Indian Point 3
Cycle 2 Eighteen (18) Case
FAC Reanalysis

Power Authority of the State of New York

Indian Point Unit No. 3

Docket No. 50-286

F_Q T NORMALIZED OPERATING
FUNCTION, $K(z)$

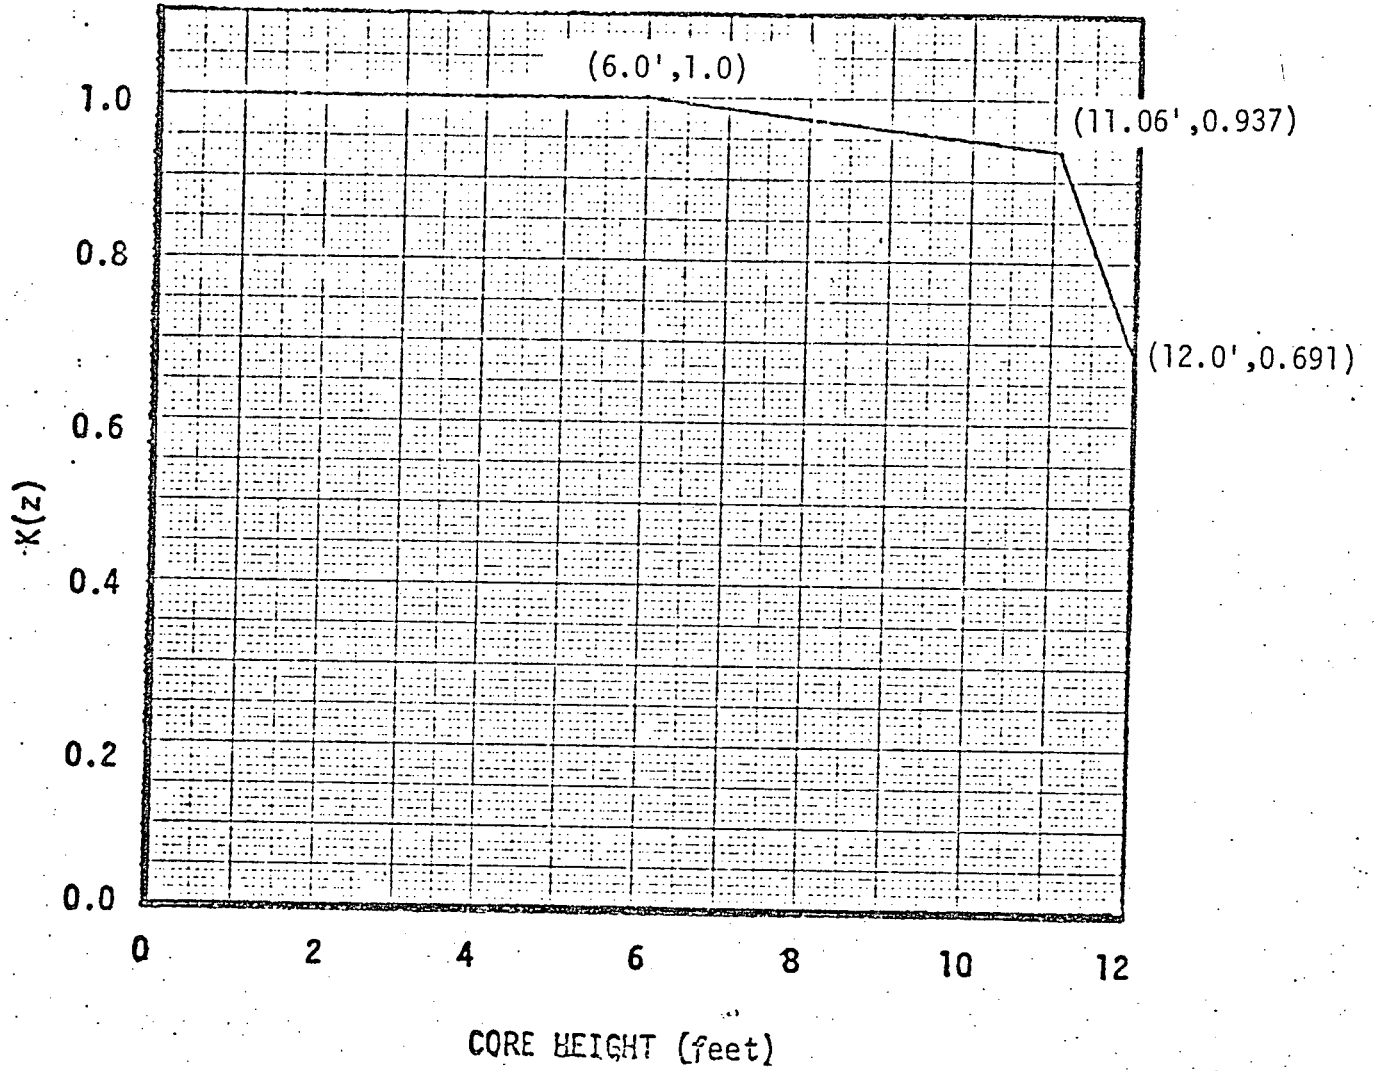
Replace Figure 3.10-2.

The increase in the K(Z) third line coordinate in Figure 2 from (12.0, 0.431) to (12.0, 0.691) assures that the Cycle 2 power control maneuvers allowed by the Technical Specifications will be satisfied. For this modified third line K(Z) segment, the small break LOCA was reanalyzed and was found to satisfy the FAC criteria.
